PROPOSED CHANGES TO KITCHEN LAYOUT IN ACCORDANCE WITH RECOMMENDATIONS MADE BY GEOFF BOND - SENIOR FOOD SAFETY OFFICER - ARUN DISTRICT COUNCIL.

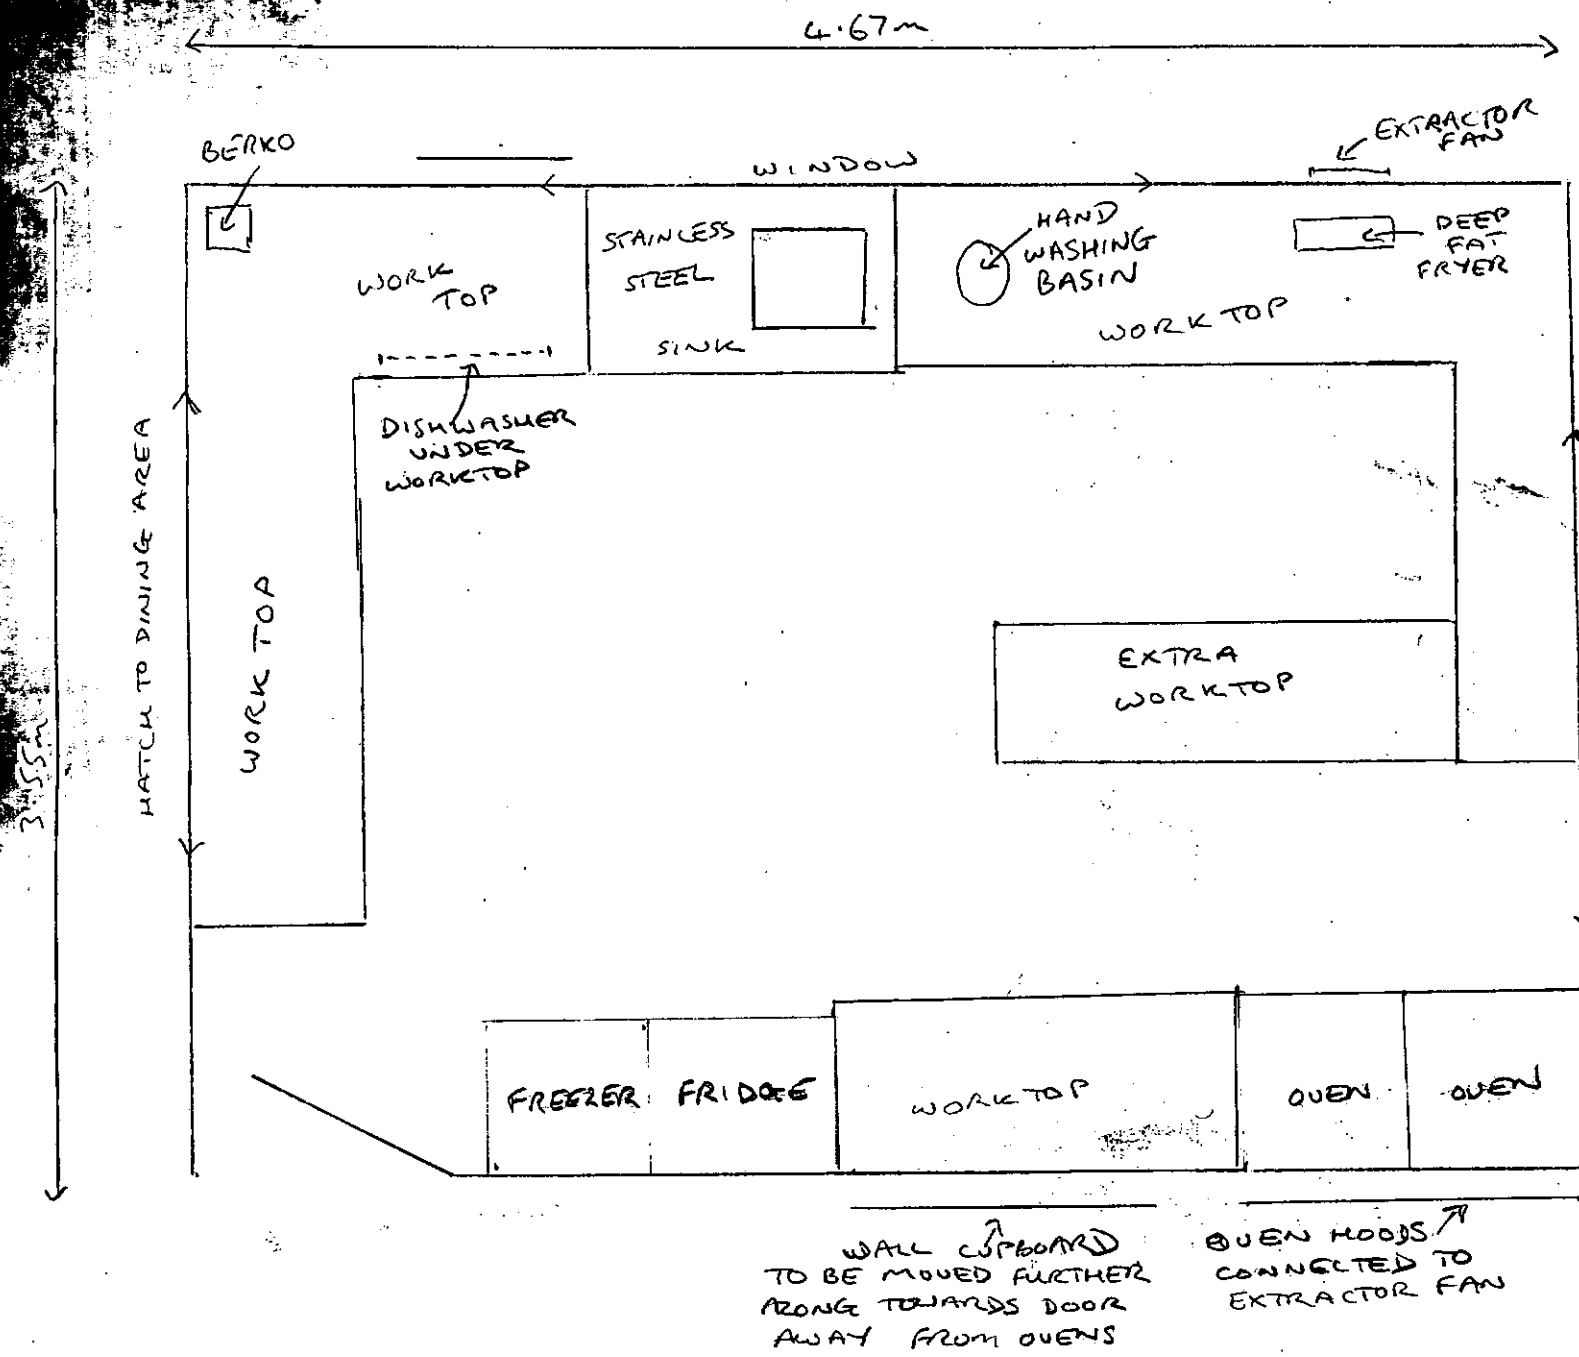
LAYOUT CHANGED SO THAT FOOD PREPARATION AND COOKING CONFINED TO ONE AREA AND DIRTY WATER AREA (WASHING) TO ANOTHER

ALL KITCHEN WORKTOPS TO BE OF STAINLESS STEEL WITH UNDERNEATH CUPBOARD STORAGE
